IEEE P802.3at Task Force Power Via MDI Enhancements

Simultaneous Operation of ALT A and B
4P Adhoc

Suggested Remedy for all 4P comments +
Addressing Task Force questions
July 2008

Isolation and 120V issue

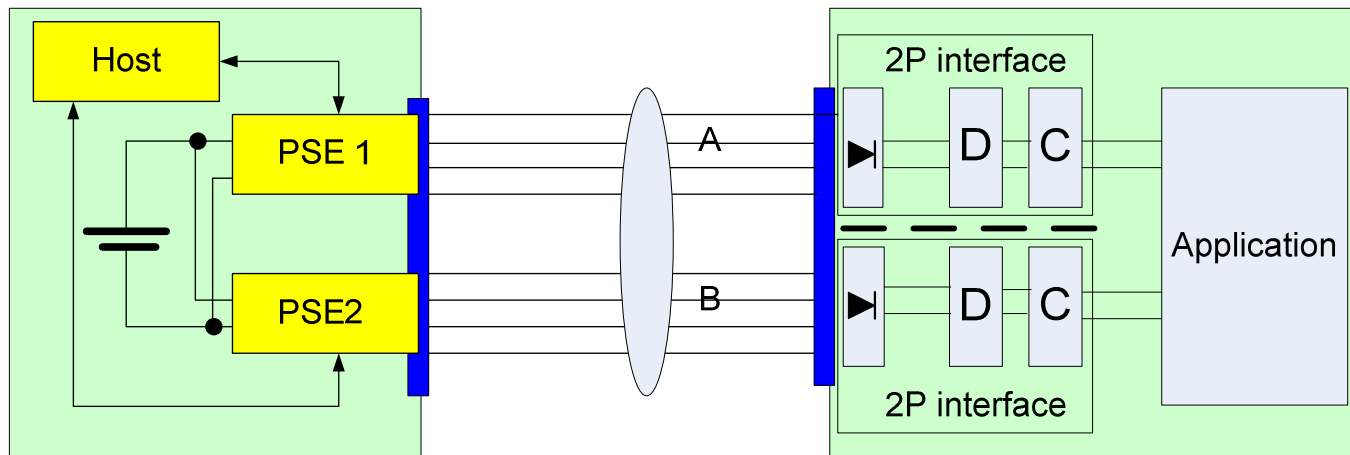
- Per the proposal: Simultaneous operation ALT A and B PSE sources that are located at different link segments are not allowed. Only the following configuration is allowed.

- These are **TWO** power system. BOTH have Detection, Classification, Powerup and Power ON states.
- PSE 1 ALT A – 2F **or** L2+1F **or** L2+2F:Detect, Classify, Power ON → Works
- PSE 2 ALT B - 2F **or** L2+1F **or** L2+2F:Detect, Classify, Power ON → Works
- PD ALT A input: Supports L1-2F and L2
- PD ALT B input: Supports L1-2F and L2
- Data of Status, Indications etc. may be passed via internal communication in PSE and PD → Implementation. **THE IDEA IS: EACH 2P MUST MEET THE 2P SPEC!**

Demonstration of IEEE802.3af current text. Figure 1

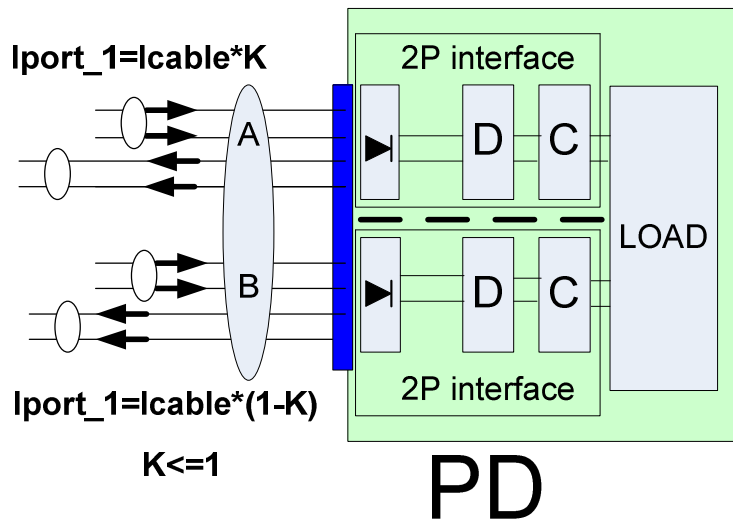
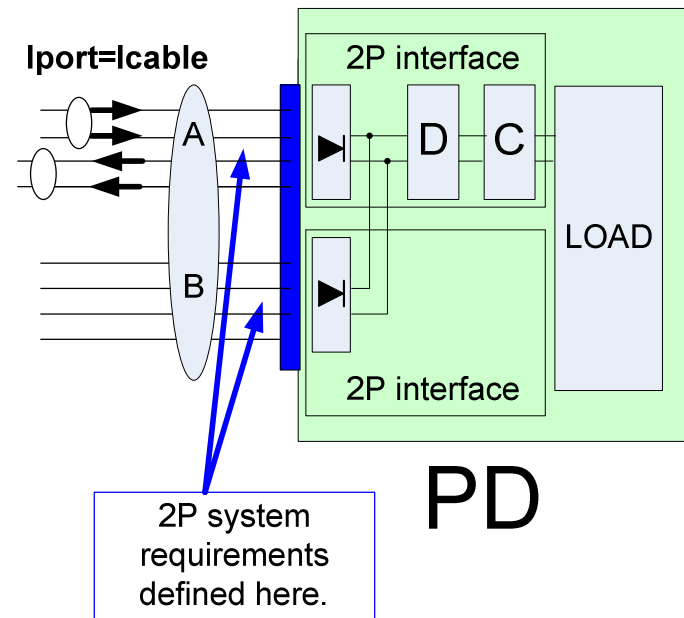
This PD is equivalent in power requirements to figure 1-1. The difference is different implementation.

However according to the current text, we can't do it..

This is what we allow today

Both PDs will work with any PSE (2P, 2x2P)

Adhoc agrees

Today We Can Do The Following....Figure 2

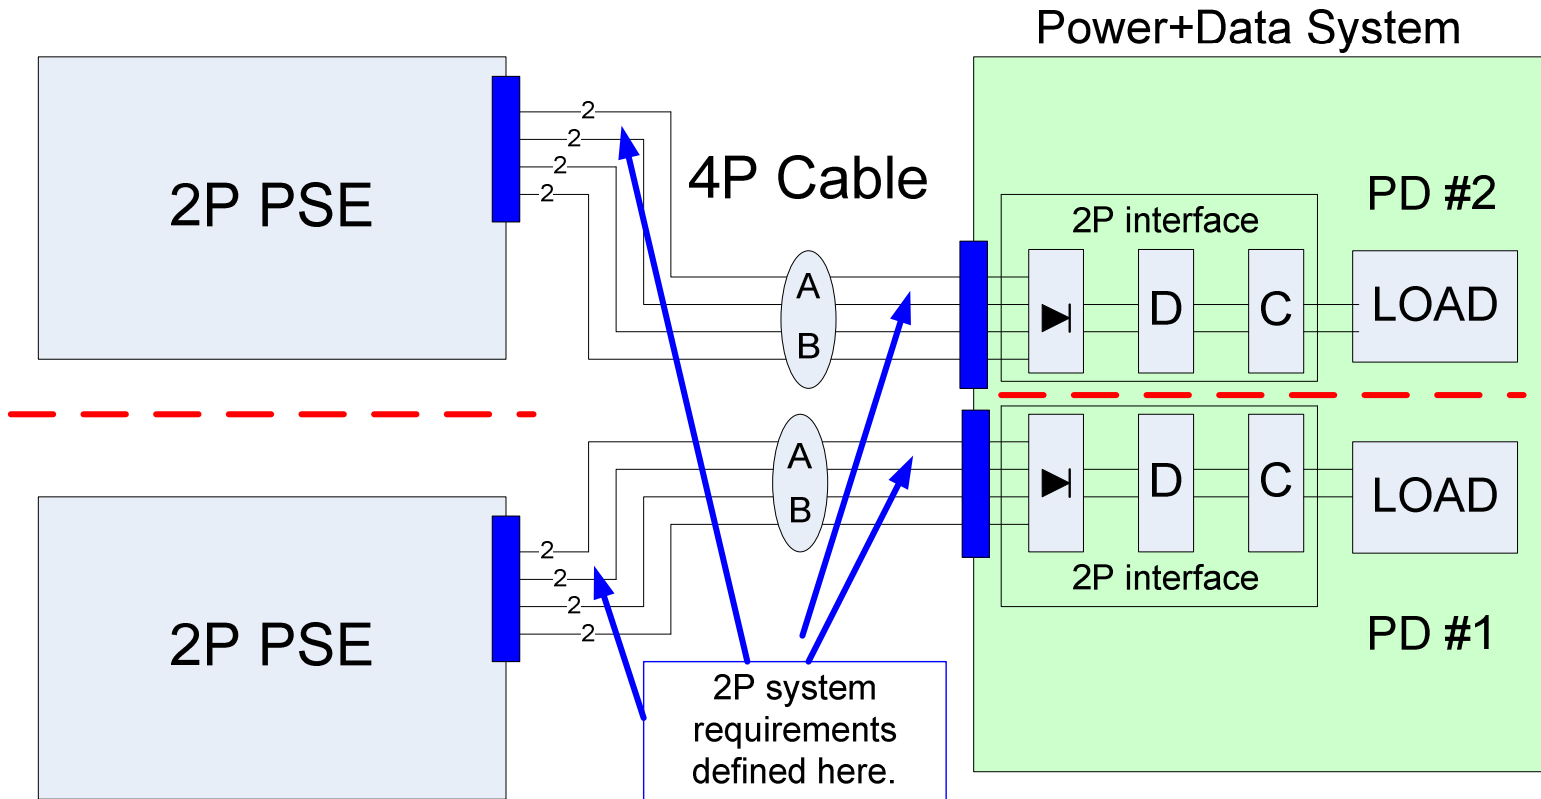
--- Environment A or B isolation as defined by IEEE802.3af
 ■ Connector. The 2 x 2P PSE may be located in the same or different box.

2 Cables. May be integrated to a single cables. All cables are simultaneously powered.

Adhoc agrees

The spec is not prohibiting Y connection – Figure 3

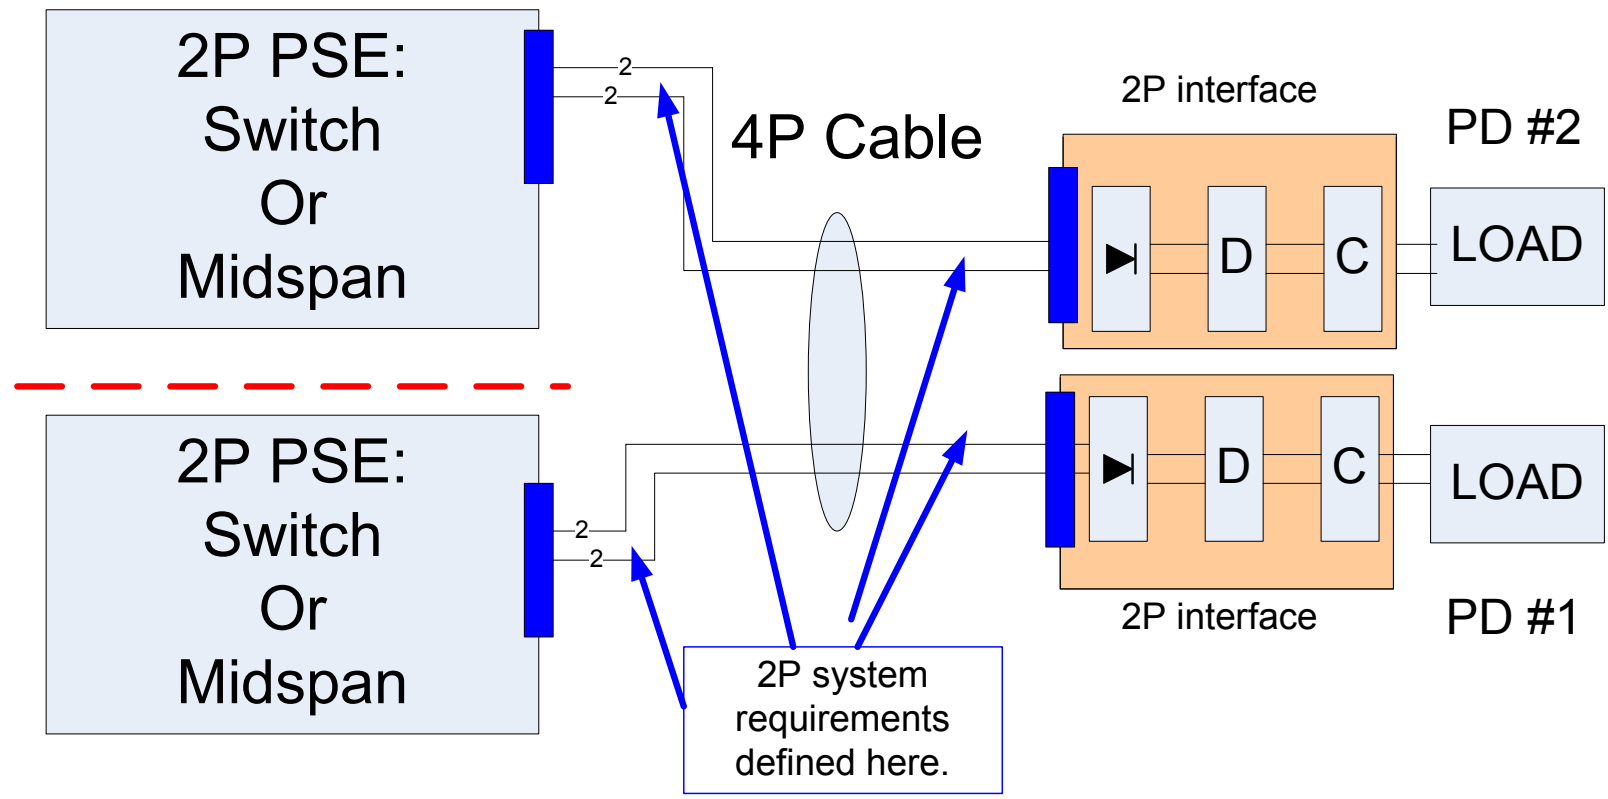
- - - - Environment A or B isolation as defined by IEEE802.3af
- Connector. The 2 x 2P PSE may be located in the same or different box, on the same cable.

Simultaneous power all pairs.

Adhoc agrees

Mispan-Switch Combinations – Figure 4

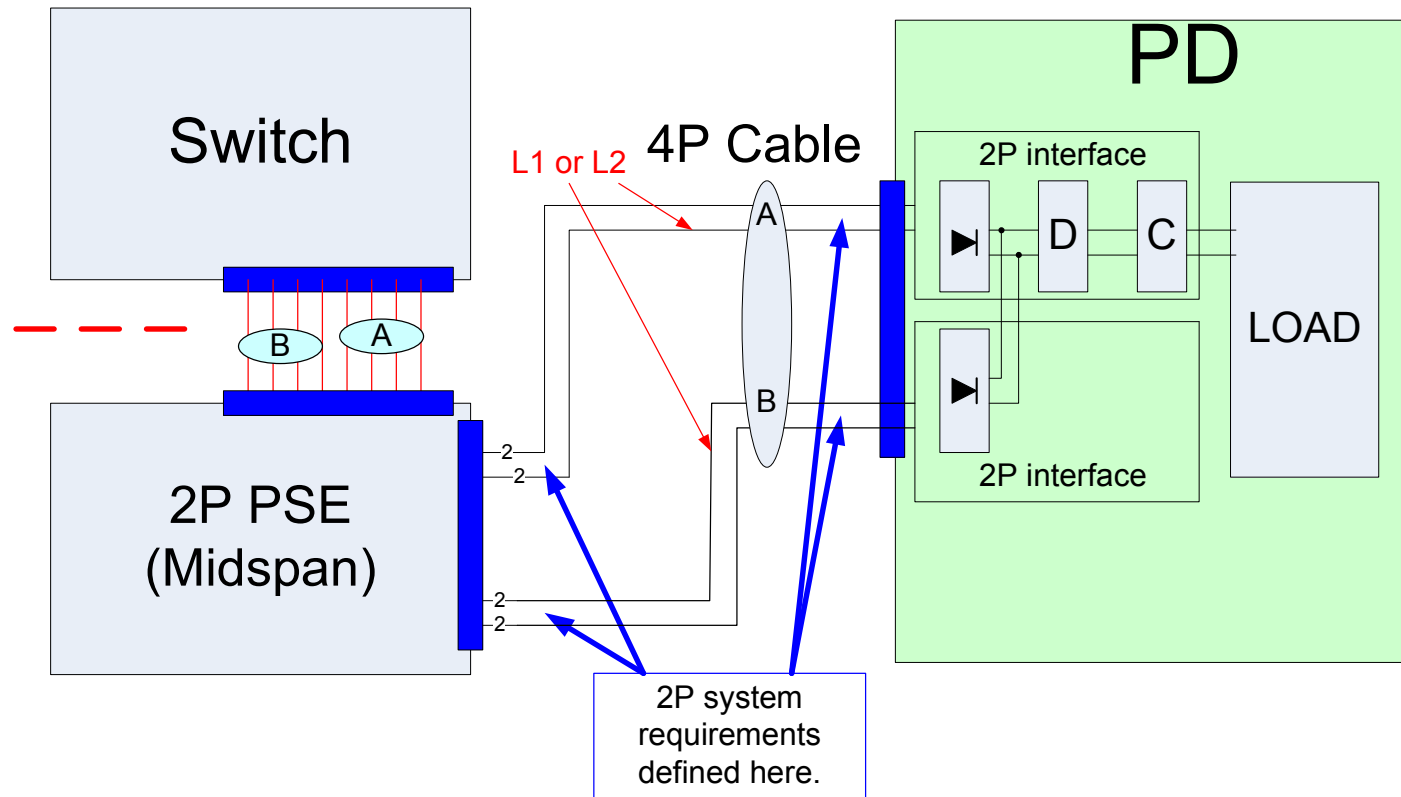
--- Environment A or B isolation as defined by IEEE802.3af
 ■ Connector. The 2 x 2P PSE may be located in the same or different box, on the same cable.

Adhoc agrees.
